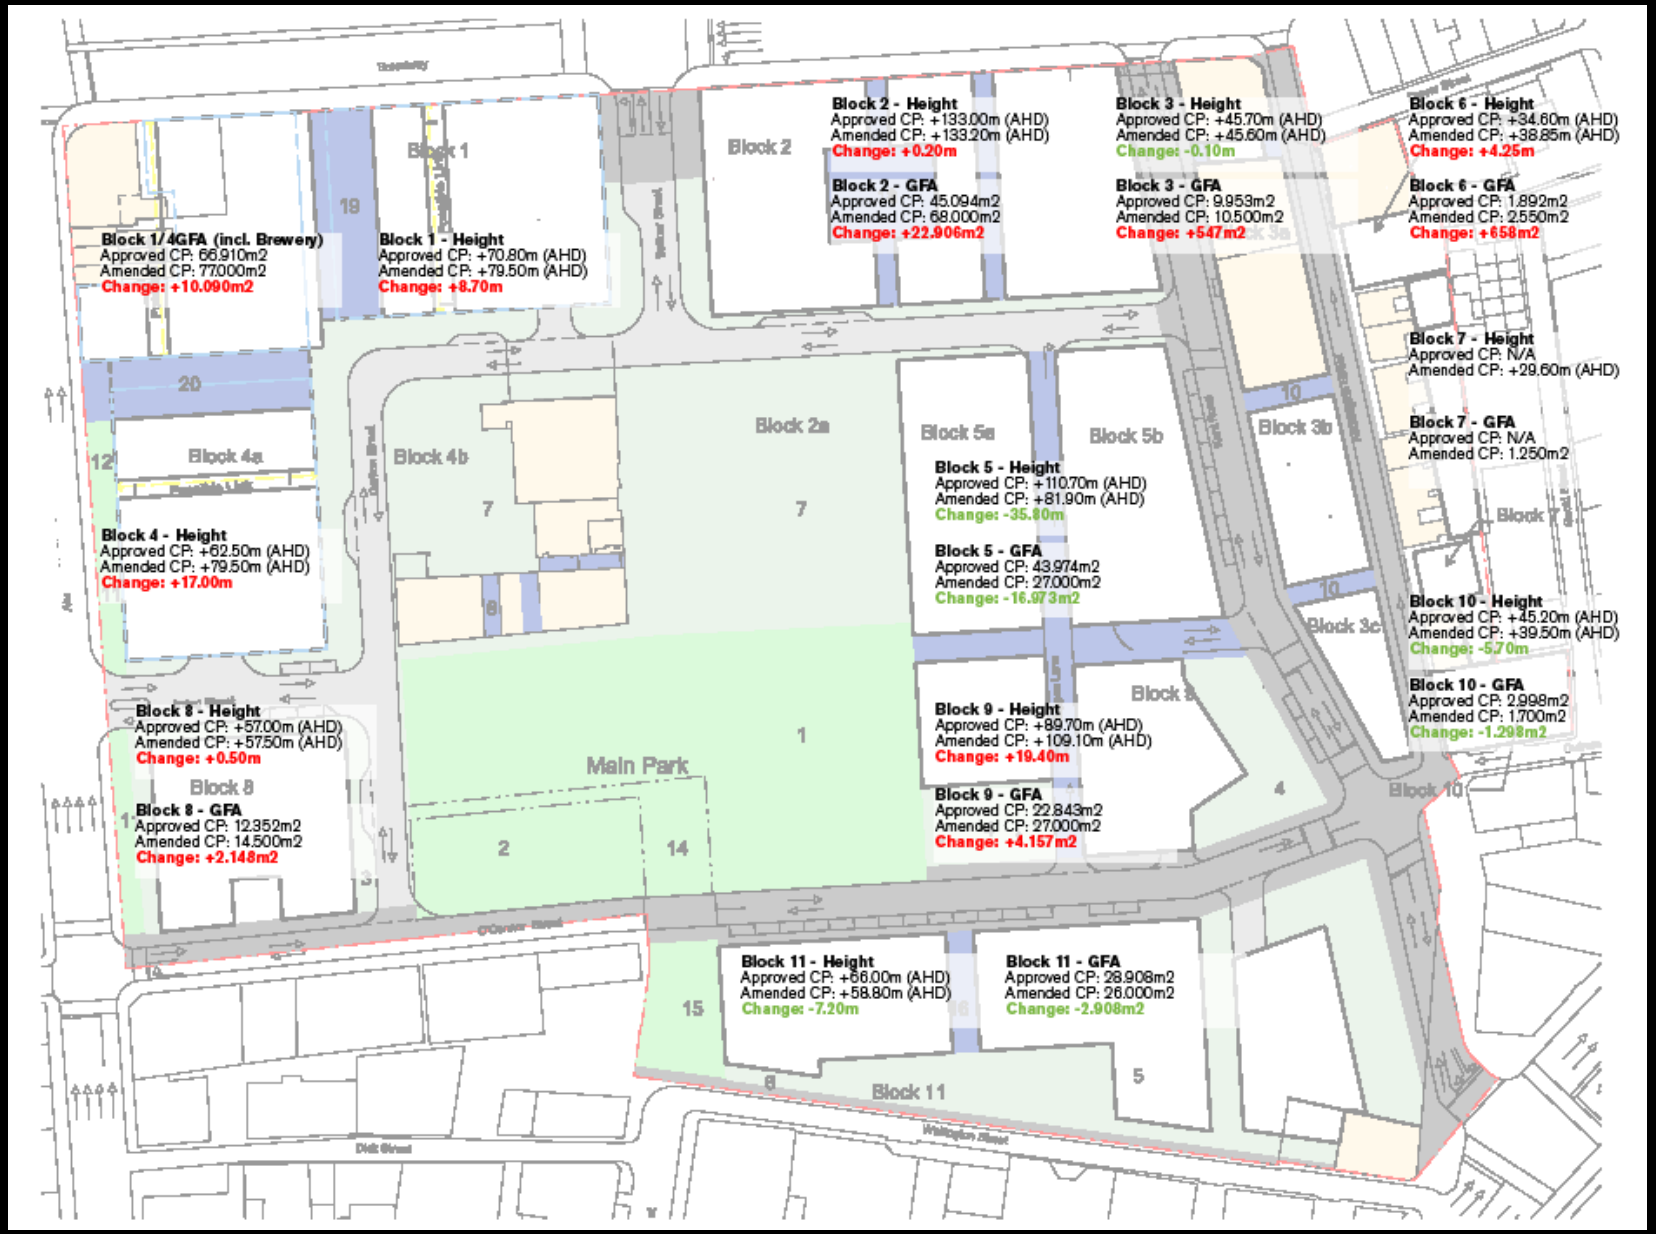
Block 1/4GFA (incl. Brewery)
Approved CP: 66,910m2
Amended CP: 77000m2
Change: +10,090m2
Block 1 - Height
Approved CP: +70.80m (AHD)
Amended CP: +79.50m (AHD)
Change: +8.70m
Block 2 - Height
Approved CP: +133.00m (AHD)
Amended CP: +133.20m (AHD)
Change: +0.20m
Block 2 - GFA
Approved CP: 45,094m2
Amended CP: 68,000m2
Change: +22,906m2
Block 3 - Height
Approved CP: +45.70m (AHD)
Amended CP: +45.60m (AHD)
Change: -0.10m
Block 3 - GFA
Approved CP: 9,953m2
Amended CP: 10,500m2
Change: +547m2
Block 6 - Height
Approved CP: +34.60m (AHD)
Amended CP: +38.85m (AHD)
Change: +4.25m
Block 6 - GFA
Approved CP: 1,892m2
Amended CP: 2,550m2
Change: +658m2
Block 7 - Height
Approved CP: N/A
Amended CP: +29.60m (AHD)
Block 7 - GFA
Approved CP: N/A
Amended CP: 1,250m2
Block 4 - Height
Approved CP: +62.50m (AHD)
Amended CP: +79.50m (AHD)
Change: +17.00m
Block 5 - Height
Approved CP: +110.70m (AHD)
Amended CP: +81.90m (AHD)
Change: -35.80m
Block 5 - GFA

Approved CP: 43,974m2
Amended CP: 27,000m2
Change: -16,973m2
Block 10 - Height
Approved CP: +45.20m (AHD)
Amended CP: +39.50m (AHD)
Change: -5.70m
Block 10 - GFA
Approved CP: 2,998m2
Amended CP: 1,700m2
Change: -1,298m2
Block 8 - Height
Approved CP: +57.00m (AHD)
Amended CP: +57.50m (AHD)
Change: +0.50m
Block 8 - GFA
Approved CP: 12,352m2
Amended CP: 14,500m2
Change: +2,148m2
Block 9 - Height
Approved CP: +89.70m (AHD)
Amended CP: +109.10m (AHD)
Change: +19.40m
Block 9 - GFA
Approved CP: 22,843m2
Amended CP: 27,000m2
Change: +4,157m2
Block 11 - Height
Approved CP: +66.00m (AHD)
Amended CP: +58.80m (AHD)
Change: -7.20m
Block 11 - GFA
Approved CP: 28,908m2
Amended CP: 26,000m2
Change: -2,908m2
Block 1
Block 2
Block 2a
Block 3a
Block 3b
Block 3c
Block 4a
Block 4b
Block 5a
Block 5b
Block 8
Block 9
Block 10
Block 11
Main Park
O'Connor Street
Bell Street
Wellington Street
Dell Street
